# Access Compliance Report

## Public Rights-of-Way

Intersection ID: 42367	Main Street: FALCONCREST_DR	Cross Street: KESTRAL_RIDGE_DR	Location: S
ADA ID: 6B307B7EC652	Ramp Type: PerpDiag	Initial Pass/Fail: Pass	Overall Compliance: No
Severity Score: 20			
Codes/Mitigation Info/Possible Solution		Field Measurements/Component Compliance

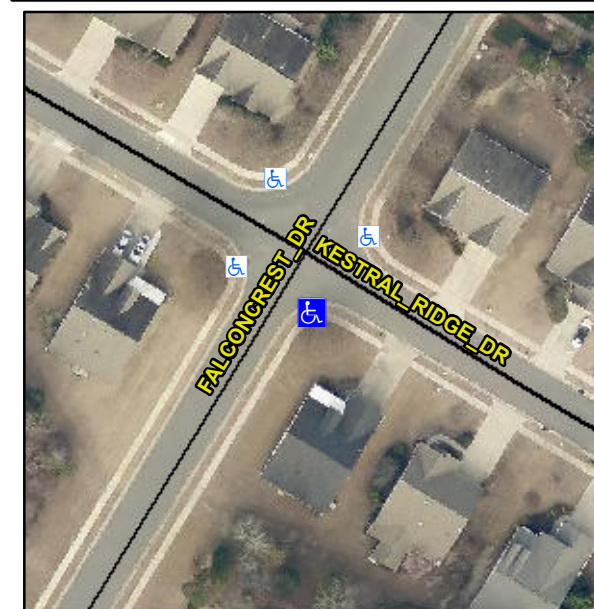
**Not Found, R304.2.2, R304.2.1, R304.2.2-Perp, R304.3.2-Para, R305, R302.7.2**

Compliance	Description	Data	Compliance	Description	Data
N/A	Ramp Length (in)	48.0	No	Ramp Slope (%)	8.5
Yes	Ramp Width (in)	50.0	Yes	Ramp XSlope (%)	0.1
N/A	Flare Type LT	Sloped	N/A	Flare Type RT	N/A
N/A	Flare Slope LT (%)	2.4	N/A	Flare Slope RT (%)	3.0
N/A	Flare Traversable LT?	No	N/A	Flare Traversable RT?	No
No	Landing Length (in)	47.0	No	DWS Provided?	No
Yes	Landing Width (in)	52.0	N/A	DWS Contrast?	No
No	Landing Slope (%)	2.6	N/A	DWS Length (in)	N/A
Yes	Landing X Slope (%)	0.5	N/A	DWS Full Width?	No
N/A	Landing Curb? (Y/N)	No	N/A	DWS Offset (in)	N/A
N/A	Shared Landing?	No			
Yes	Gutter Ponding?	No	Yes	Gutter Slope (%)	0.2
No	Gutter Lip Ht (in)	0.5	Yes	Gutter X Slope (%)	0.0
N/A	Painted X Walk1?	No	N/A	Painted X Walk2?	No
	X Walk 1 Direction	To NE		X Walk 2 Direction	To NW
N/A	X Walk 1 Width (in)	N/A	N/A	X Walk 2 Width (in)	N/A
	X Walk 1 Slope (%)	1.6		X Walk 2 Slope (%)	3.4
	X Walk 1 X Slope (%)	1.7		X Walk 2 X Slope (%)	1.3

**Remove & Replace Curb Ramp With Two New Directional Ramps or Equivalent.**
